产品开发更改

DC No. / 开发更改编号: RBCE-PDECR2026006

Customer project Name/ 客户项目名称:	JP360
--------------------------------	-------

F03ZS0000B-04

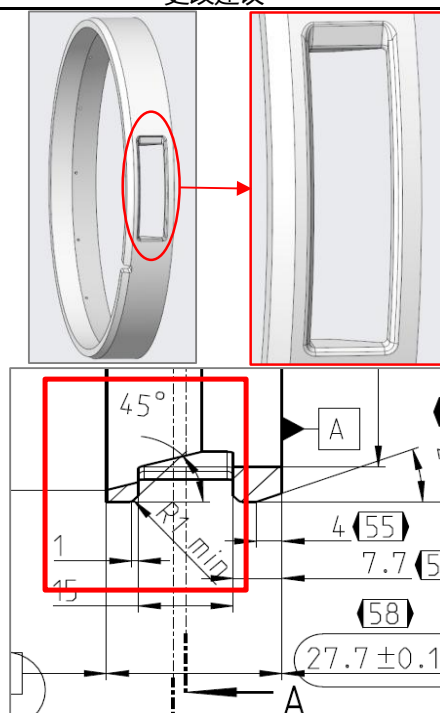
导油环回油口处未设计倒角，入机壳时导油环发生卡滞，压装不到位

回油口无倒角

回油口增加: C角1x45°和圆角R1

回油口增加C角和圆角，避免压装发生卡滞
